WILLIAMSON COUNTY, TEXAS

CHANGE ORDER NUMBER: 6

**SE Loop Seg 1 Ph 1
Williamson County Project No. T3346**

Change Order No. 6

DESIGNED:	PROJECT NUMBER		ROADWAY	
CHECKED:			SE LOOP	
DRAWN:	STATE	COUNTY	CITY	SHEET No.
CHECKED:	TEXAS	WILLIAMSON		15A

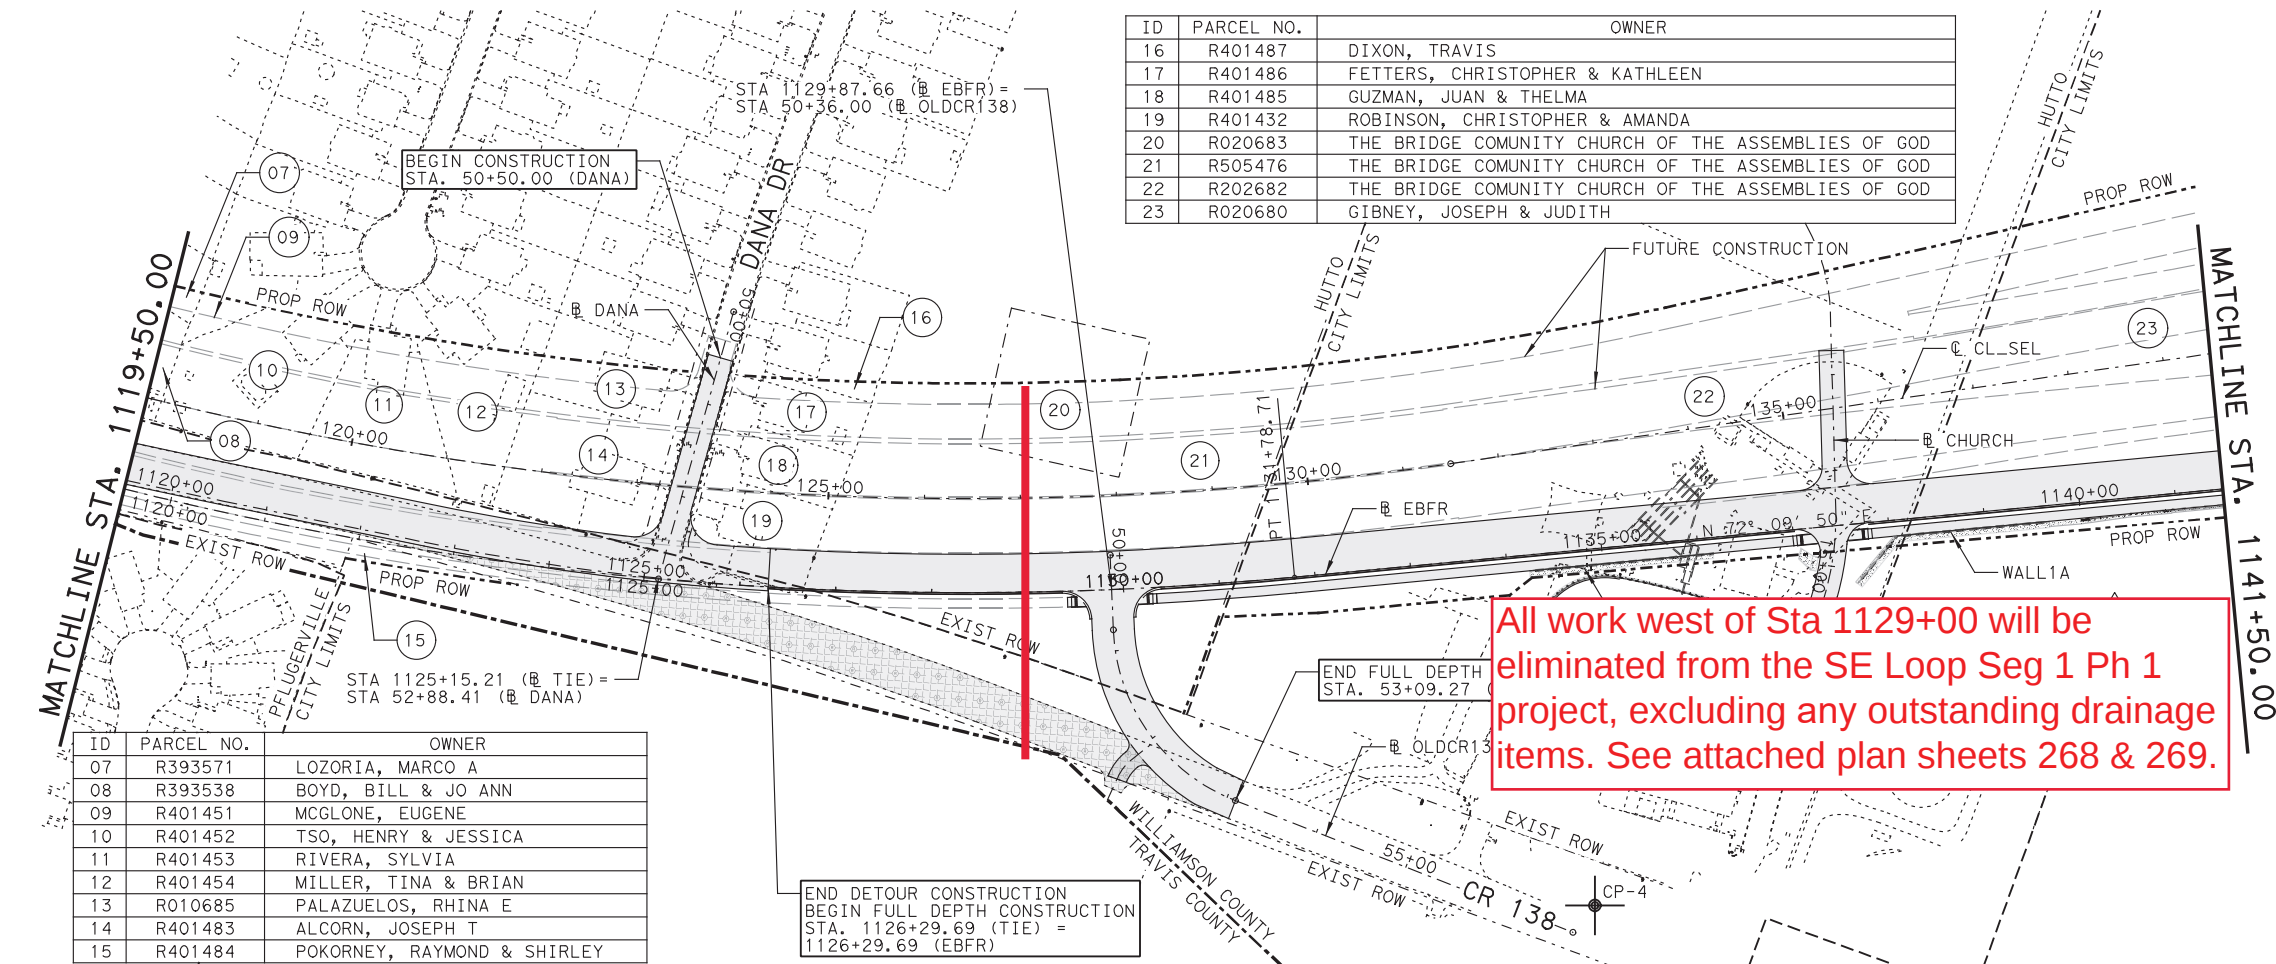
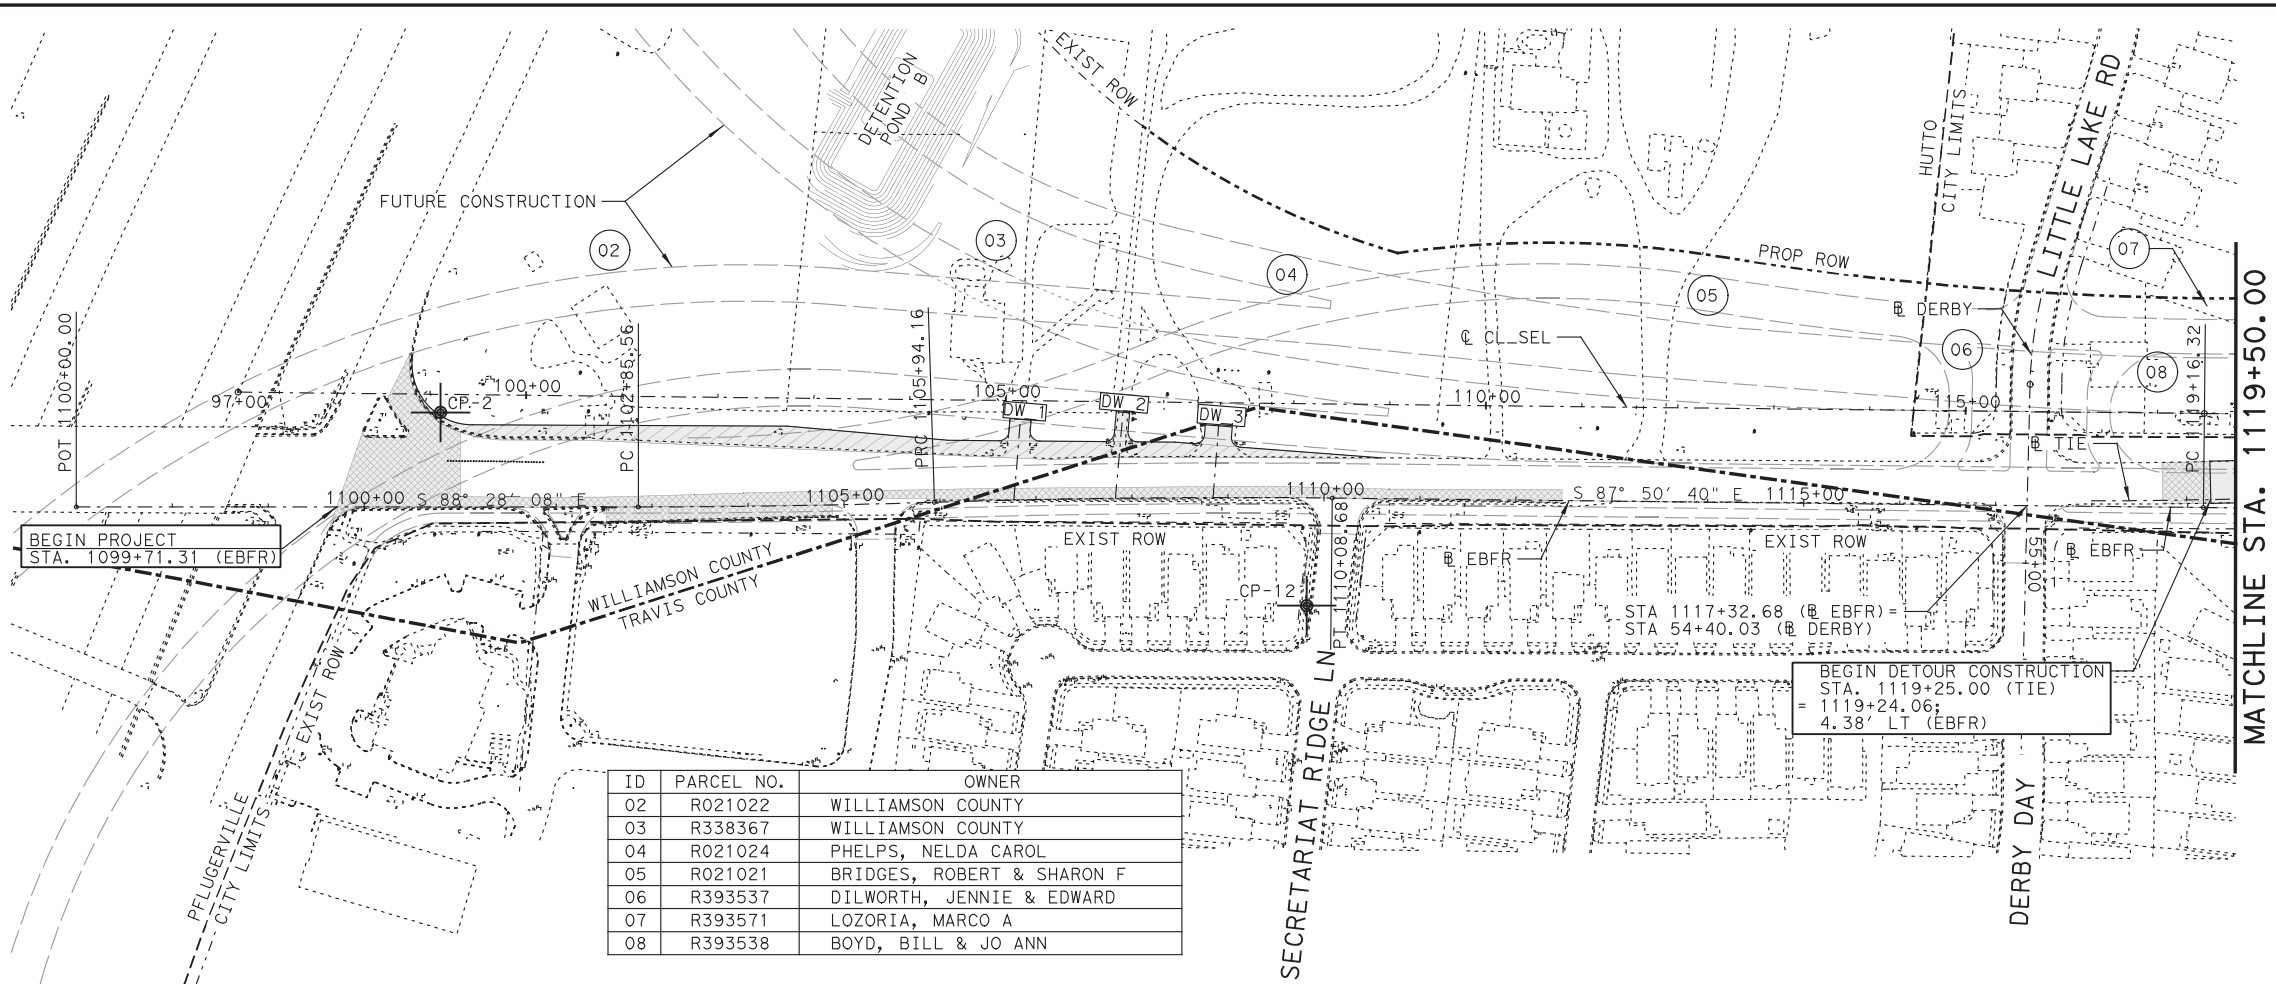
Qty's from previous sheet.
30,354 & 57,265

Totals including previous sheet.

Revised earthwork
qty's, per RFI #16 and
Change Order #5.

SE LOOP SEGMENT 1 PHASE 1 PROJECT LAYOUT

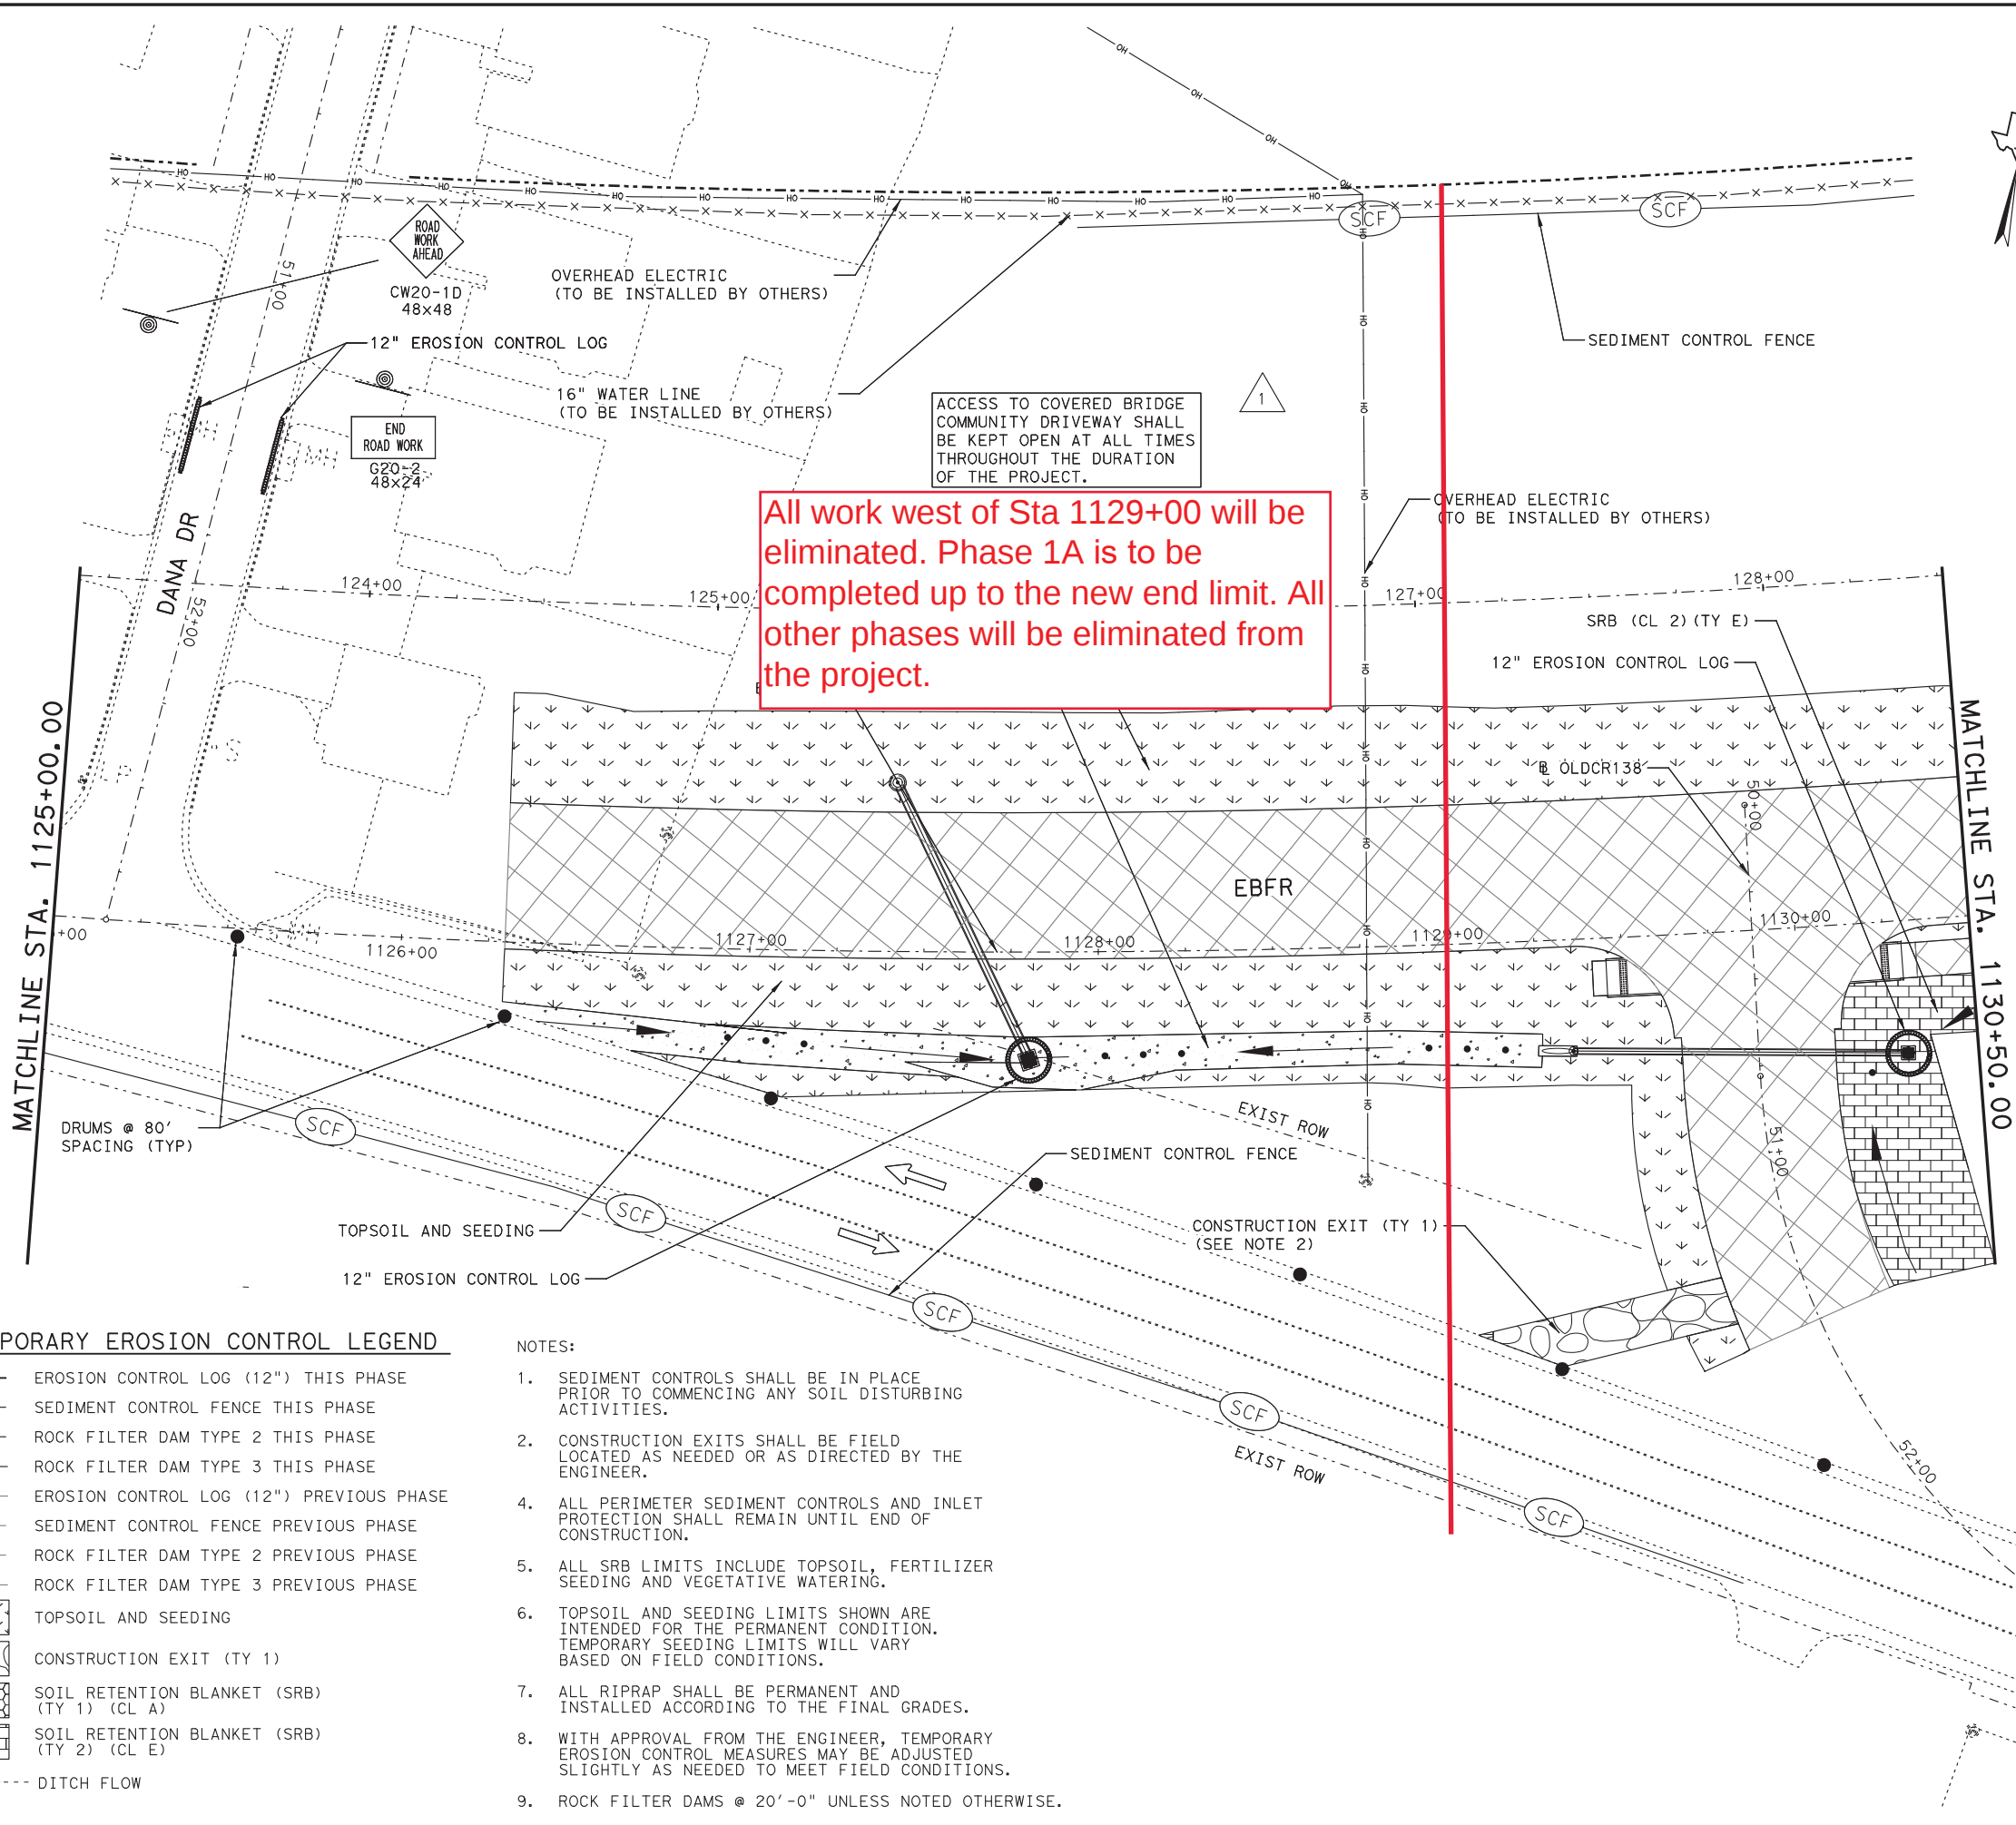
All work west of Sta 1129+00 will be eliminated from the SE Loop Seg 1 Ph 1 project, excluding any outstanding drainage items. See attached plan sheets 268 & 269.

DESIGNED:	PROJECT NUMBER		ROADWAY	
CHECKED:			SE LOOP	
DRAWN:	STATE	COUNTY	CITY	SHEET NO.
CHECKED:	TEXAS	WILLIAMSON		143

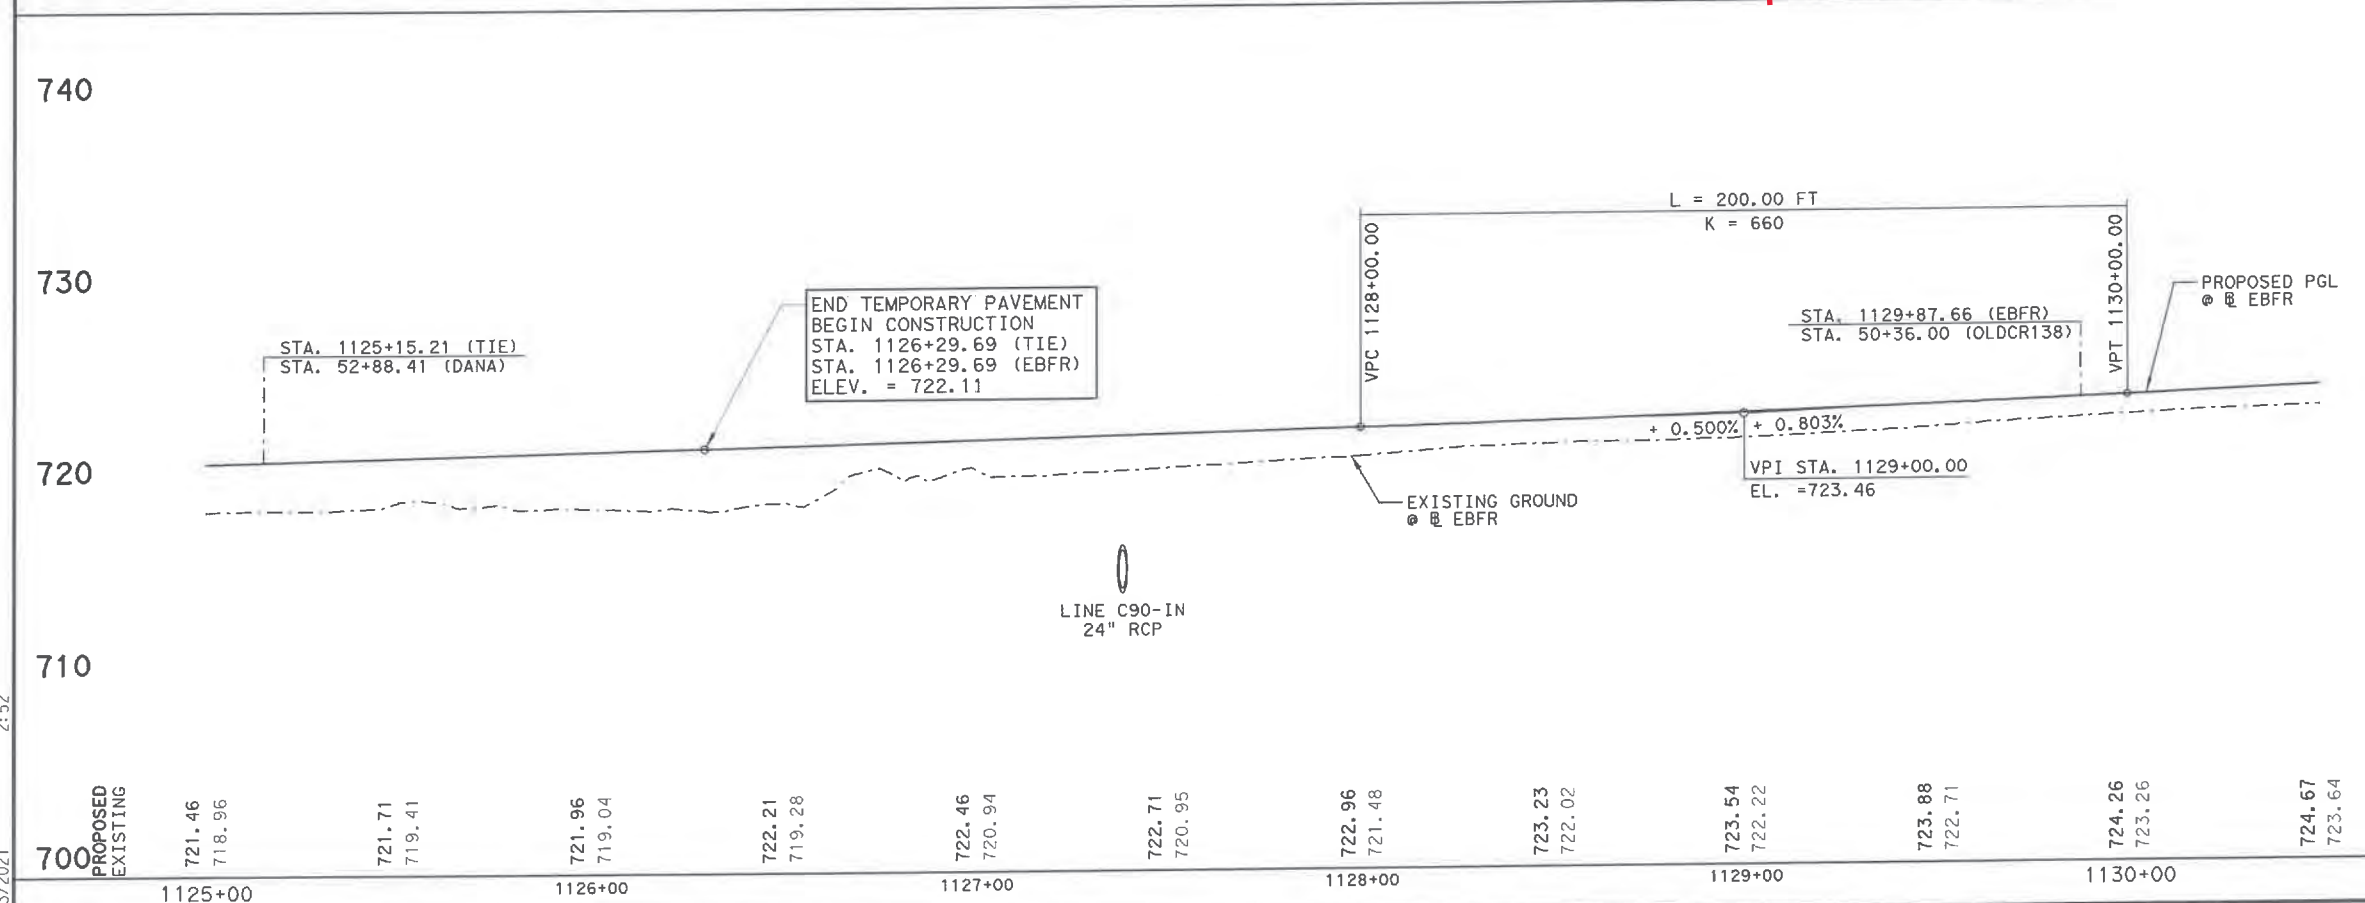
As discussed in the meeting with JCG and HNTB, the new western limit of the project will be 1129+00 with exception to the remaining drainage items.
